STAFF REPORT

SUBJECT: H-2021-0103
Ferney Subdivision

Annexation and Zoning of 5.64 acres with a request for the I-L zoning district and a Preliminary Plat consisting of two (2) building lots on 4.93 acres of land in the requested I-L zoning district.

A. Annexation & Zoning Legal Description and Exhibit Map

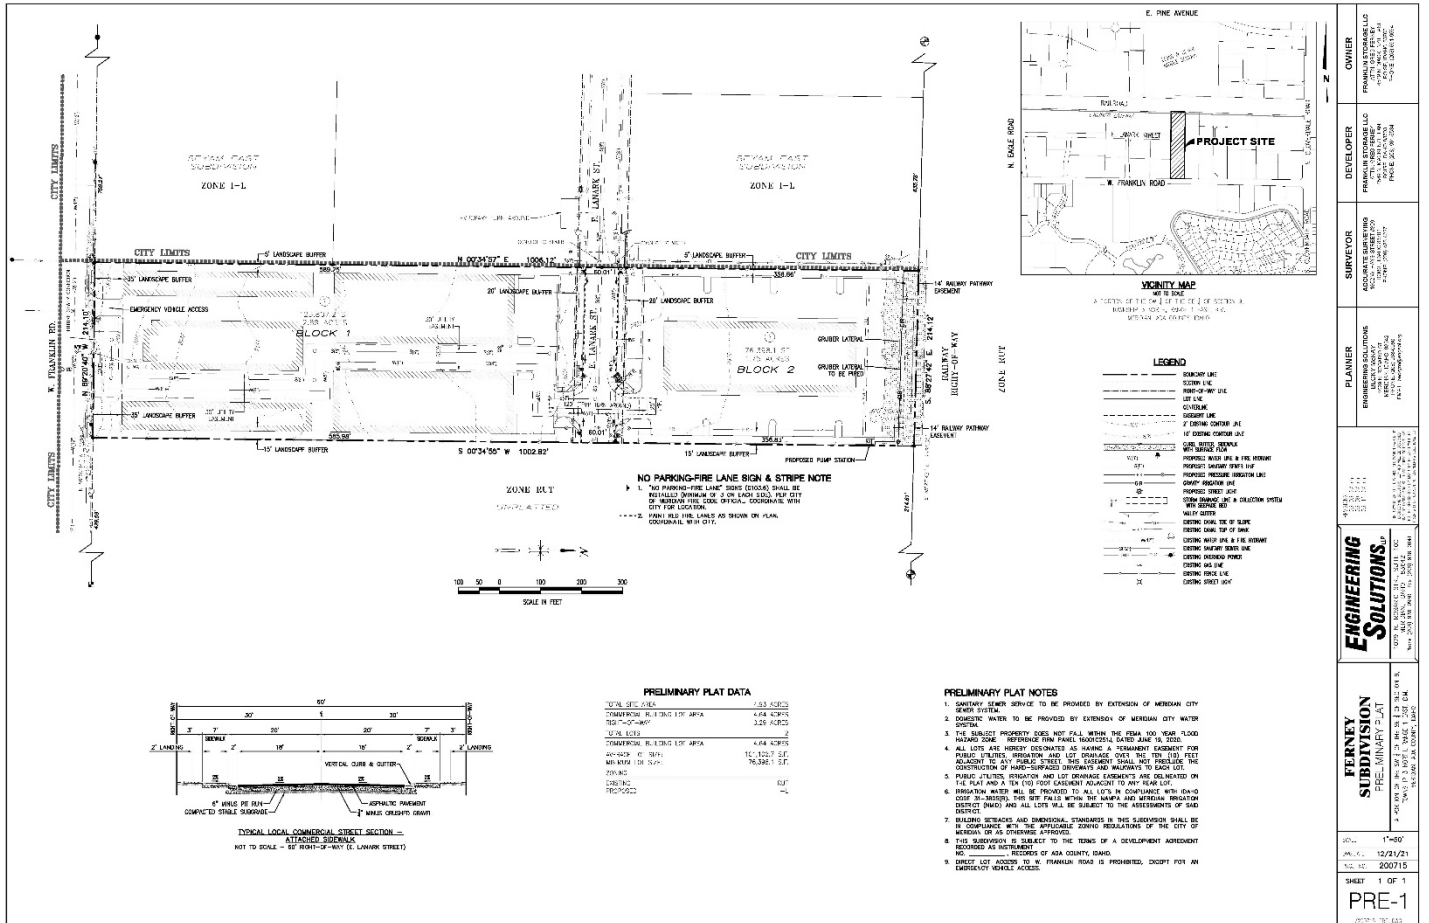
The Applicant is proposing to annex approximately 5.64 acres of land which is larger than the property size of 4.93 acres. This discrepancy is due to the Applicant being required to annex land to the centerline of adjacent right-of-way. In this case, this area includes Franklin Road right-of-way south of the property and railroad right-of-way north of the property.

With previous applications north of the subject site, Applicants did not annex to the centerline of the railroad right-of-way which was a mistake and the City did not catch it. In light of this, Staff is asking the Applicant to revise their annexation and zoning request to include the full railroad right-of-way instead of just to the centerline. Staff has included this comment within the conditions of approval.

Please submit a revised annexation legal description and exhibit map 15 days prior to the City Council hearing that includes the full width of the railroad right-of-way north of the subject site.

B. Preliminary Plat (dated: December 21, 2021)

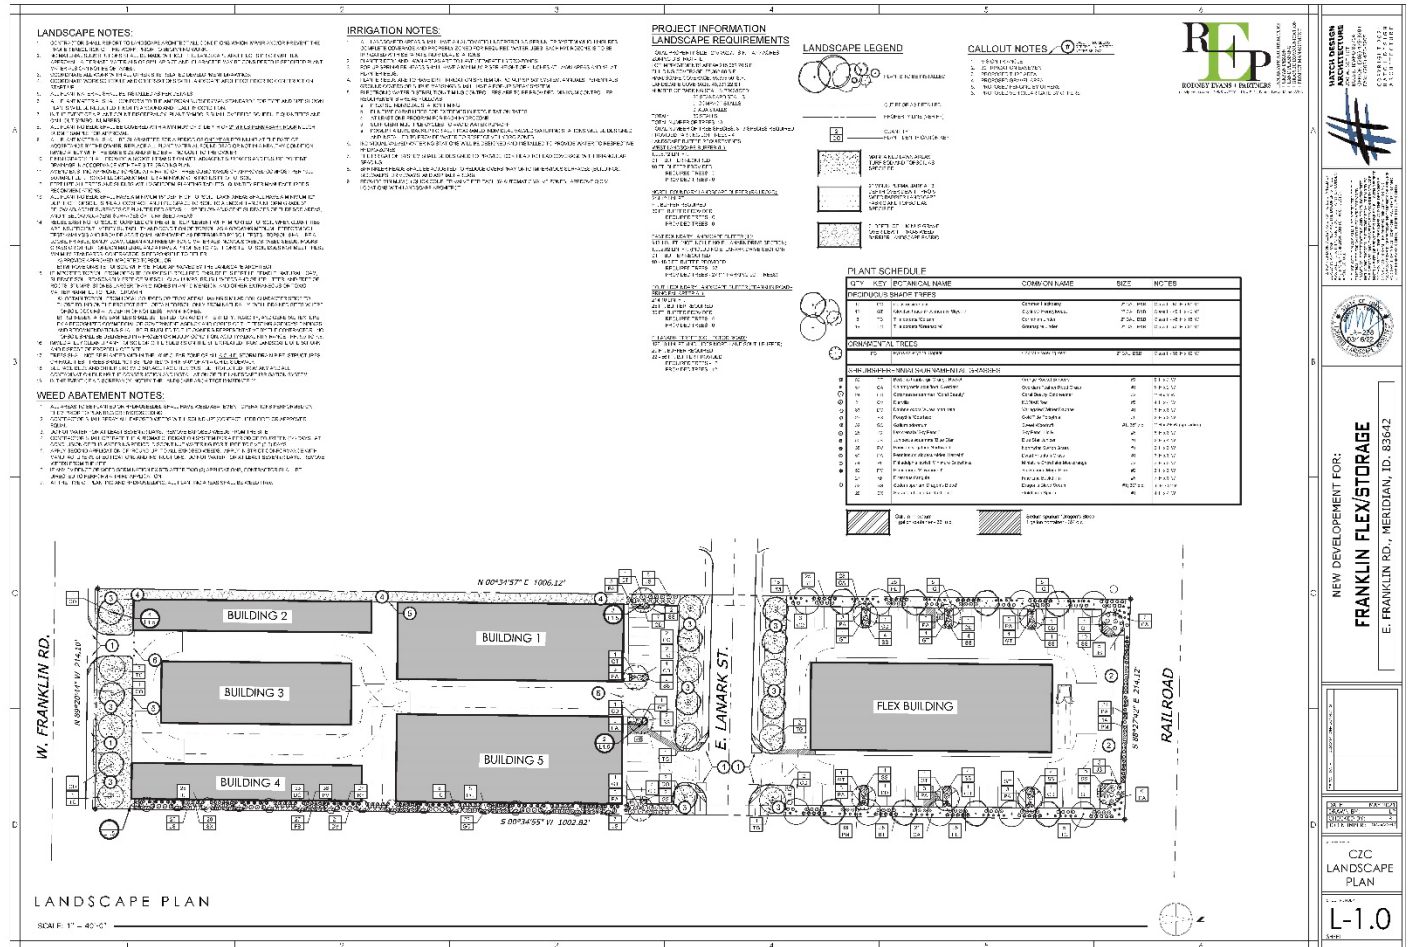
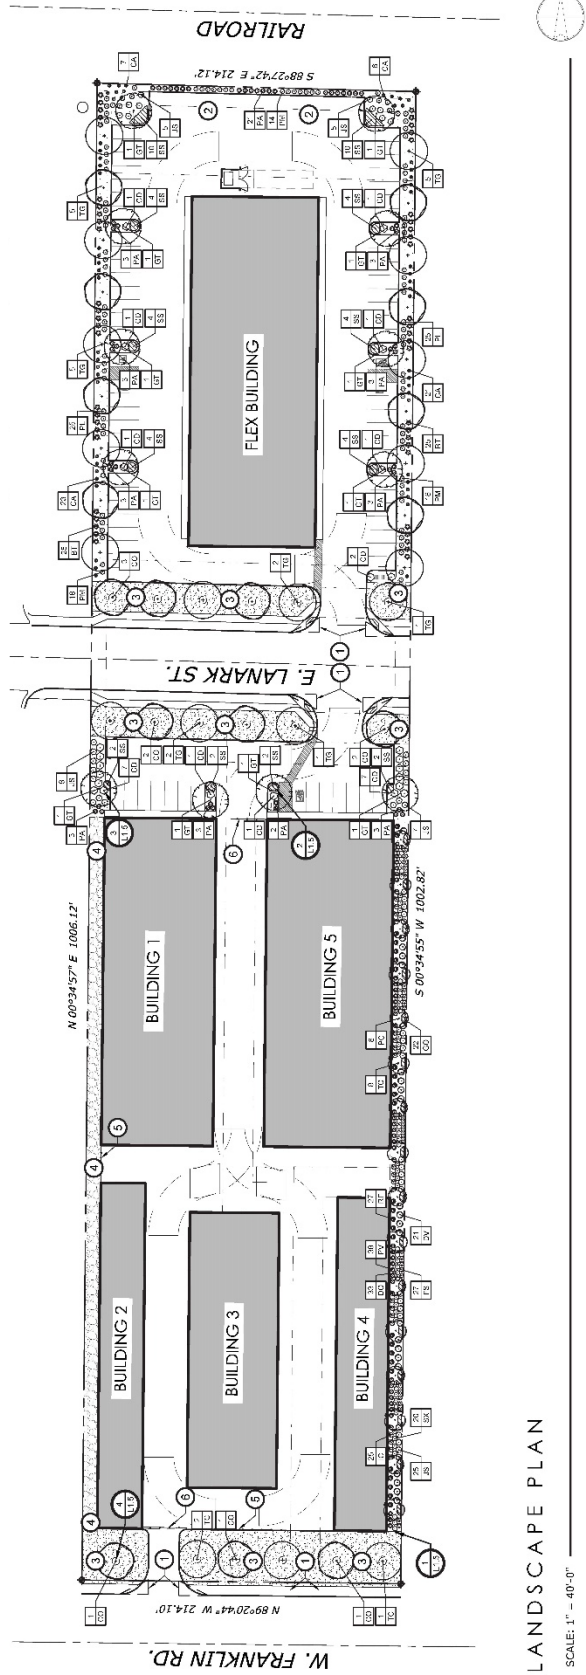
A 20-foot wide landscape buffer is required on both sides of the E. Lanark Street extension, an industrial collector street—the submitted plat depicts at least a 20 feet wide easement on both sides of this road extension measured from approximately the middle of the detached sidewalk. Therefore, the parkway strips between the sidewalks and back of curb for Lanark are not shown as part of the landscape easement.

2. The preliminary plat included in Section VII.B, dated December 21, 2021, shall be revised as follows at least fifteen (15) days prior to the City Council hearing:
 - a. Show the required landscape easements adjacent to E. Lanark Street to include the parkways along Lanark and start at the back of curb.
3. The landscape plan included in Section VII.D, stamped on March 16, 2022, shall be revised as follows at least fifteen (15) days prior to the City Council hearing:
 - a. Per UDC 11-3B-7C.3, depict no more than 65% of the landscape buffer area to be comprised of grasses for all required landscape street buffers (adjacent to Franklin and Lanark).

- b. Per UDC 11-3B-7C.3 for development along entryway corridors, depict additional landscape features within the 35-foot buffer along E. Franklin Road.

- c. Include additional trees and show they will touch at maturity along the east property boundary for a minimum of the first 185 feet measured from the back of the existing sidewalk for additional screening.

- d. Depict the proposed type of fencing on a sheet within the landscape plans to ensure compliance with UDC 11-3A-7 and the applicable specific use standards. Chainlink fencing with or without slats does not qualify as a screening material in accord with UDC 11-3B-5M.

C. Landscape Plan (stamped date: March 16, 2022)

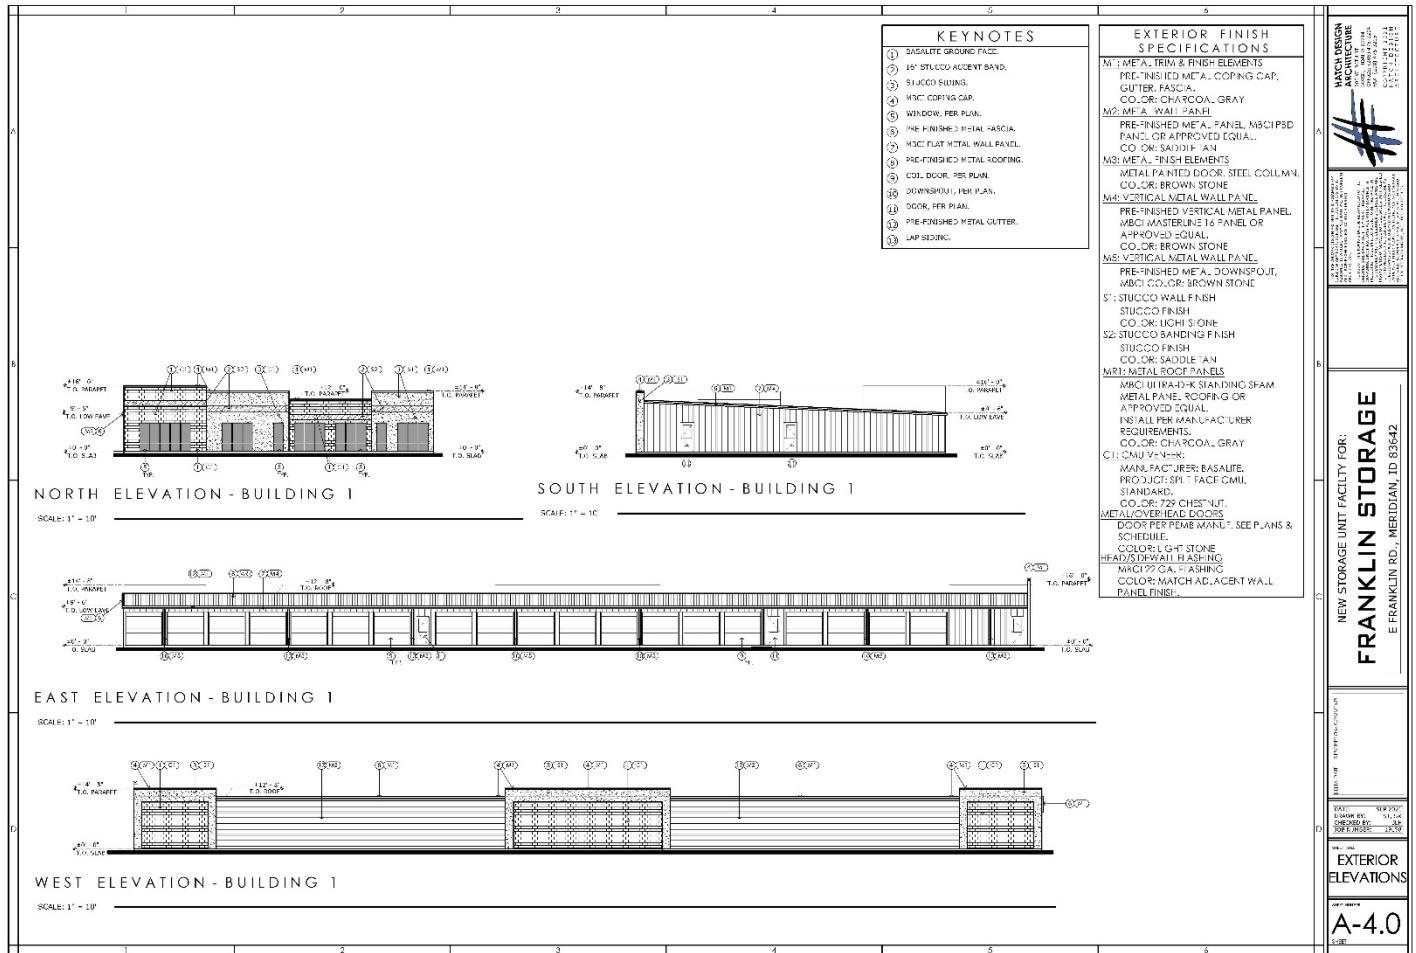
A minimum 35-foot wide street buffer is required adjacent to E. Franklin Road, an arterial street and labeled as an entryway corridor. This buffer is required to be landscaped per the standards listed in [UDC 11-3B-7C](#). According to the submitted plat and landscape plans, a minimum 35-foot landscape easement is depicted adjacent to Franklin, measured from the back of sidewalk. *The submitted landscape plans confirm the minimum width of the landscape buffer but do not appear to show code compliant vegetation. Per UDC 11-3B-7C.3, no more than 65% of the landscape buffer area shall be comprised of grasses and additional landscape design is required along entryway corridors. Therefore, additional vegetative ground cover beyond that of grasses and additional landscape features are required to meet UDC standards. For example, as outlined in code, landscape features may include berms of no less than four to one (4:1) slope at a three-foot minimum height, decorative landscape walls (no greater than three (3) feet in height), decorative open vision fencing (no greater than four (4) feet in height), or a dry creek design with river rock, boulders, etc. are acceptable to meet this standard. Staff has included a condition of approval to comply with this standard. However, there are existing power poles along the Franklin frontage so the Applicant will be limited to Class I trees only; this does not preclude the Applicant from meeting the maximum ground cover percentage noted above.*

Staff has concerns with the parkways strips not being included within the landscape buffer easements along Lanark and the lack of any vegetation shown within these parkways on the submitted landscape plans. Staff recommends the landscape buffer easement be extended to the back of curb to comply with the UDC and to revise the landscape plans to show additional grasses within the parkway strip. Further, the landscape buffers along Lanark do not show the required vegetative ground cover, similar to the Franklin buffer. Therefore, Staff is also including

No fencing is shown on the submitted landscape plan but fencing is required per the specific use standards for the proposed self-service storage facility use adjacent to the existing residential use to the east. Staff is including a condition of approval to include code compliant fencing along the entire east property boundary.

Because this area of the plat is adjacent to a vehicular use area around the Flex building, parking lot landscaping is required per UDC 11-3B-8 and should include trees and other vegetative ground cover. The submitted landscape plans do not depict any trees within this area as the irrigation easement does not allow trees. Further, the Applicant will need to obtain a license agreement with the irrigation district in order to construct what is shown on the landscape plans. Staff does not find what is proposed on the landscape plans to comply with the minimum code requirements discussed. The Applicant should submit for Alternative Compliance with the future final plat to propose an equal or superior means of complying the landscaping outlined in UDC 11-3B-8 within or adjacent to the Evans Drain easement.

a condition of approval to add additional vegetative ground cover beyond grass to comply with UDC 11-3B-7C.3.

D. Conceptual Building Elevations (full file linked [here](#))

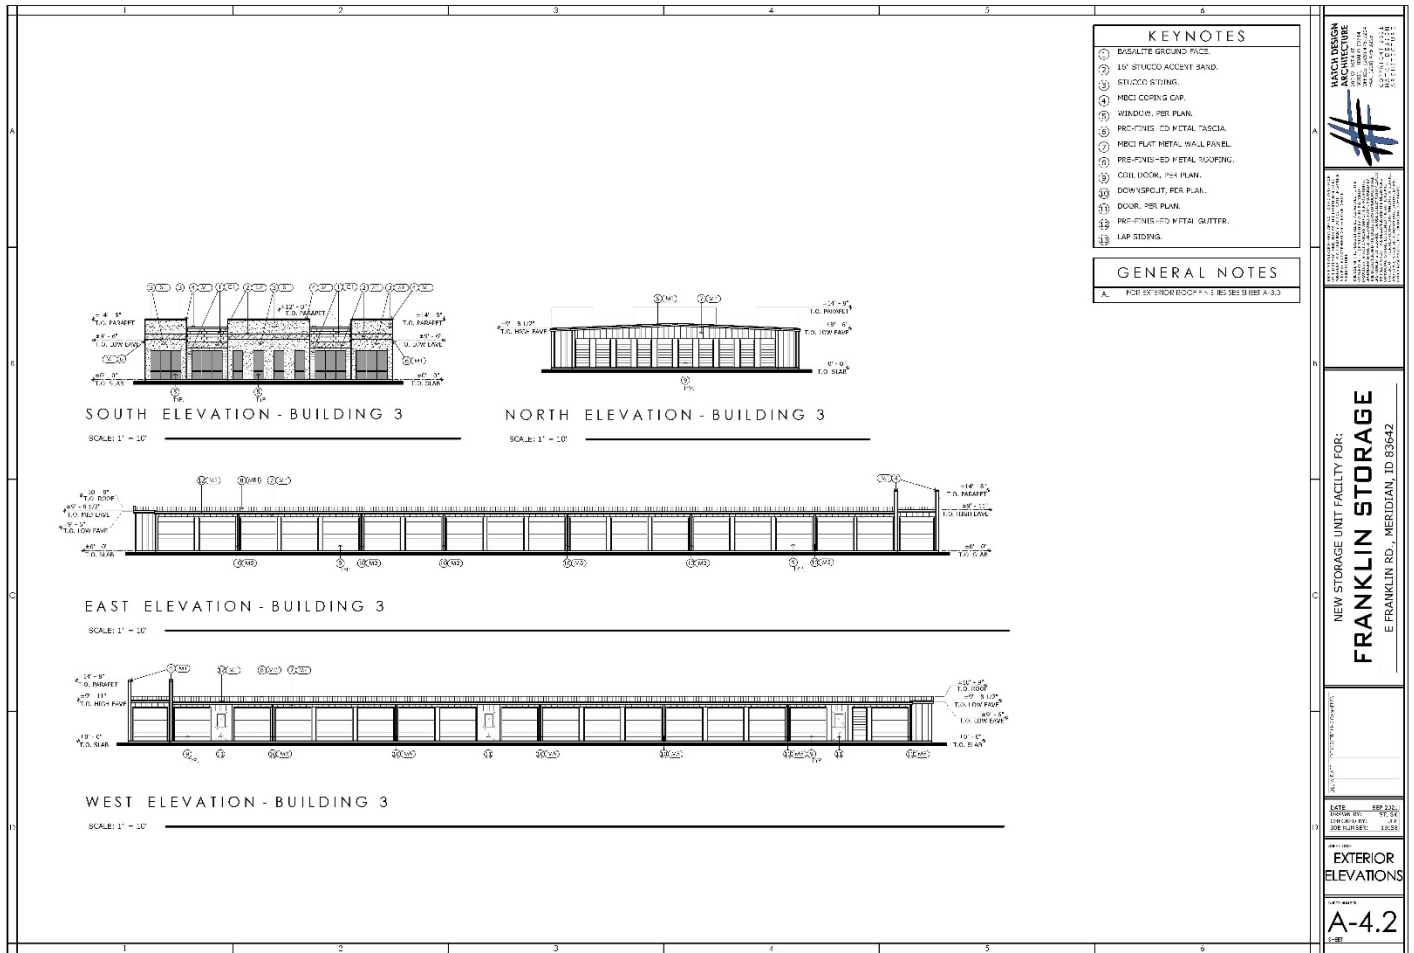
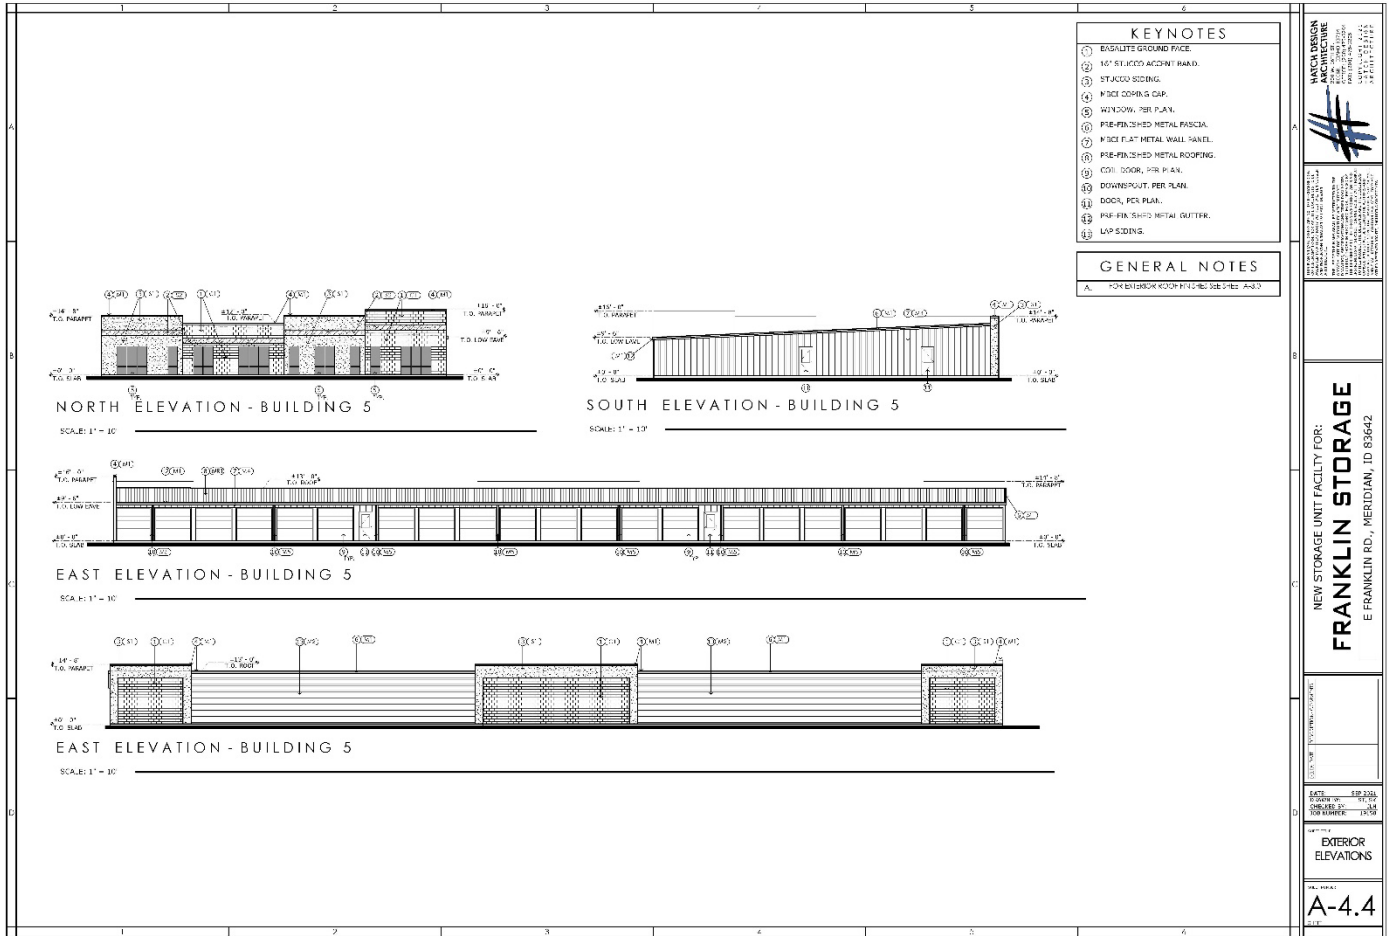
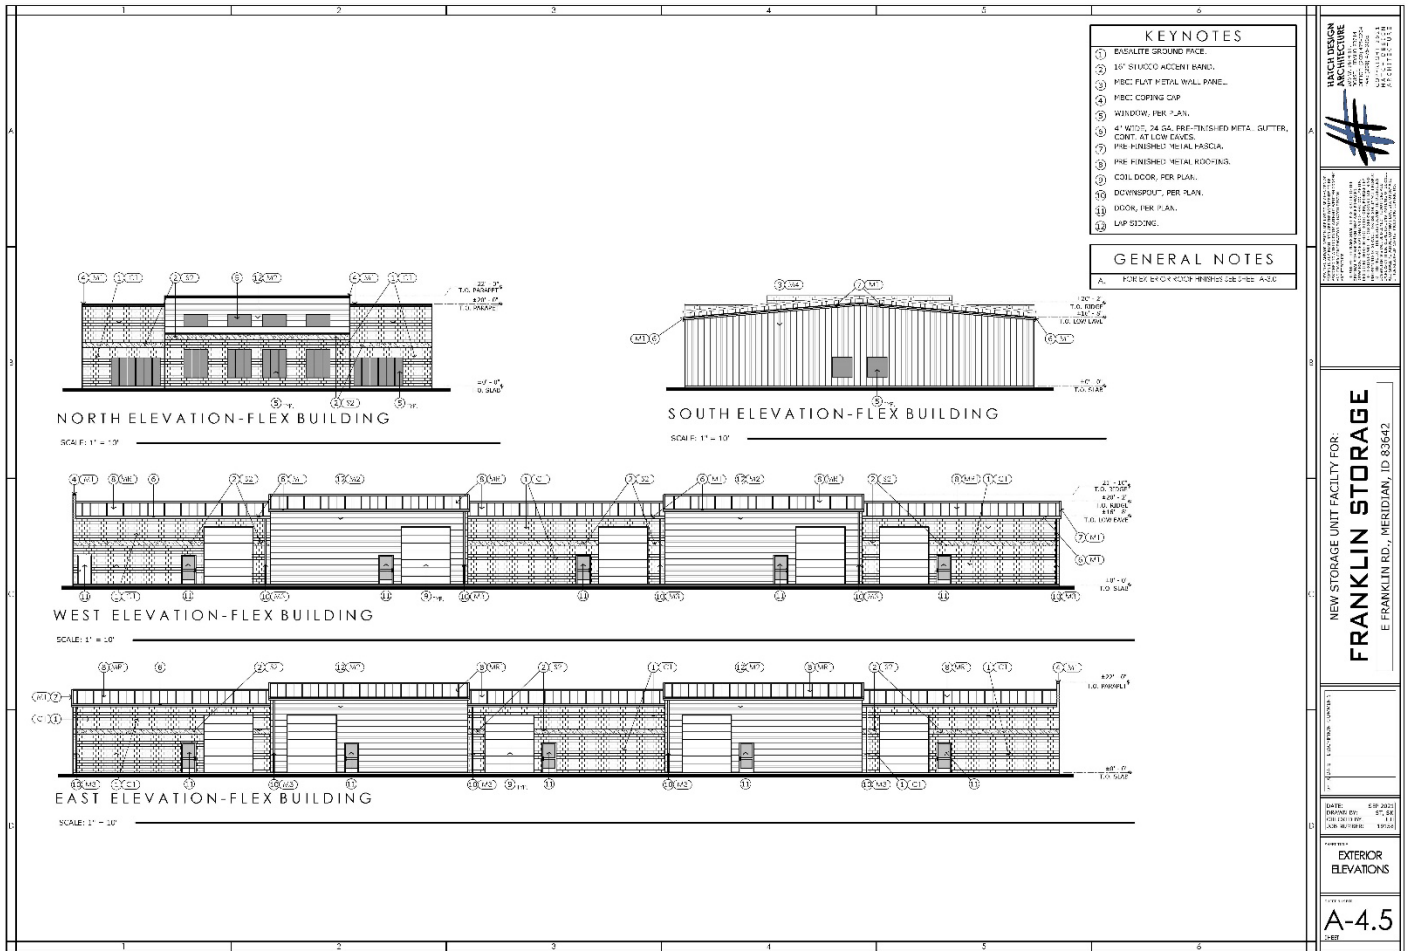
The conceptual elevations submitted depict 17-foot tall storage buildings at their highest and a 21-foot tall flex building. The storage buildings vary in overall size but appear to show varying roof profiles and finish materials facing relevant areas (roadways and the residence to the east). However, it is not entirely clear if the paneling shown facing the residence is metal or otherwise; metal paneling will not be allowed as a future field material. Overall, Staff finds the conceptual elevations should comply with the relevant standards but will review it in more detail at the time of CZC and Design Review submittal.

- f. The Applicant shall comply with the Commercial architectural design standards in the City of Meridian's Architectural Standards Manual (ASM) at the time of Certificate of Zoning Compliance and Design Review submittal for the elevations facing Franklin and the east elevations of the two storage buildings adjacent to the existing residence on Parcel S1109438907.
